Community Development
Department

STAFF REPORT

Meeting Date:	May 28, 2026
Agenda Title:	Work Session: 22 Waterloo Street
Requested Action:	Work session review of proposed rear addition, façade improvements, and hardscape alterations at Red Truck Bakery
Department / Agency Lead:	Community Development
Staff Lead:	Whitney Burgess

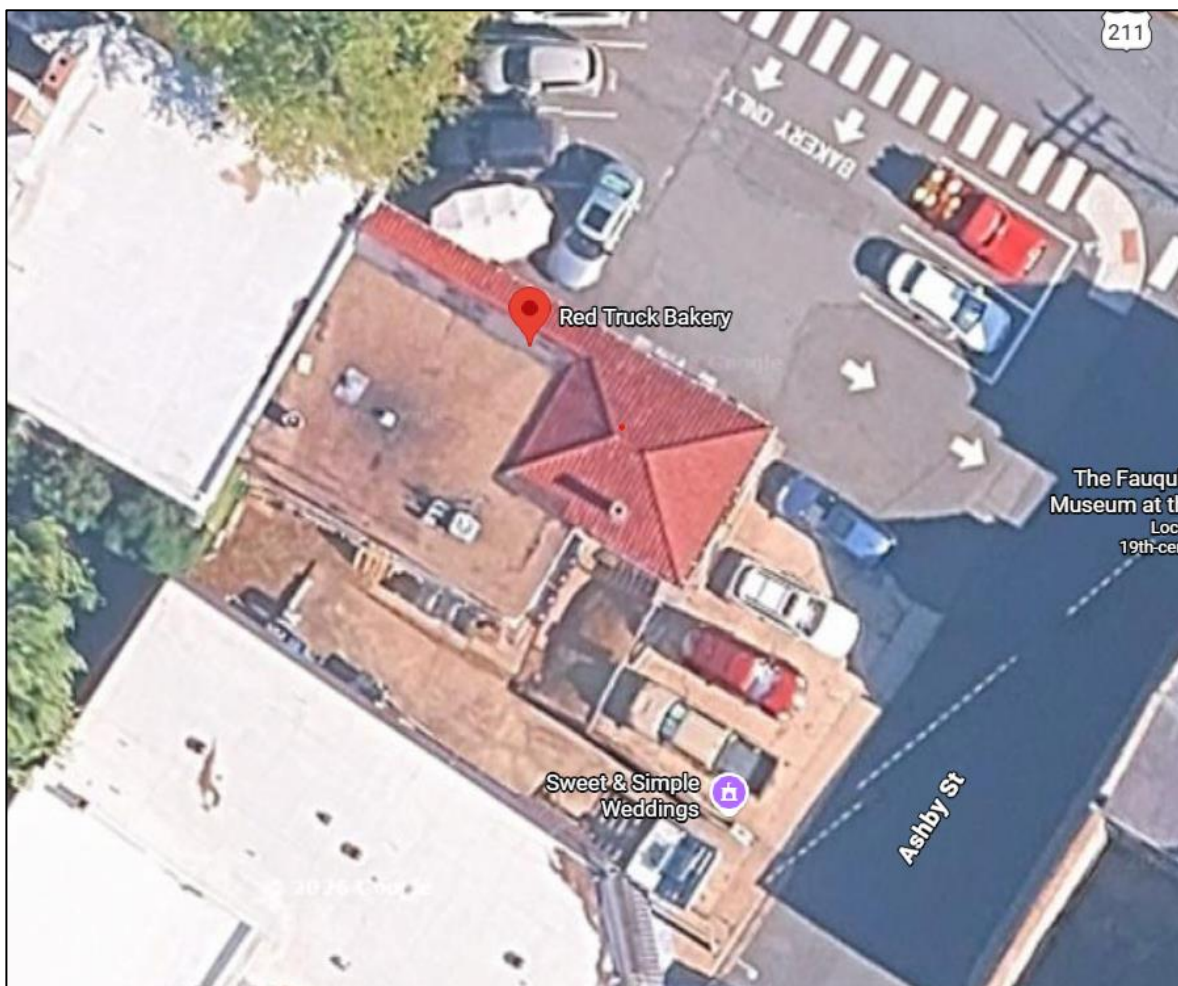
3. Parking – The proposed work must accommodate at least one handicapped parking space on the lot and provide an accessible pathway/entry to the building. The applicant should revise the plan prior to ARB approval.

The application needs to demonstrate adequate parking to meet Article 7 – with the expanded seating areas, this appears to be a Restaurant, Fast Food use. The minimum required number of on-site parking spaces is 1 parking space per 150 square feet of gross floor area. In the CBD district, there are specific parking reductions that they may qualify for, as listed in Section 7-9 and 7-13 of the Zoning Ordinance. The applicant must demonstrate that they qualify for these parking reductions. I strongly recommend that they demonstrate their compliance with the parking requirements prior to any approval by the ARB.

Minimum parking space size requirements and minimum drive aisle widths must be met, as found in Section 7-17 of the Zoning Ordinance. As a recommendation, this should be demonstrated prior to ARB approval.
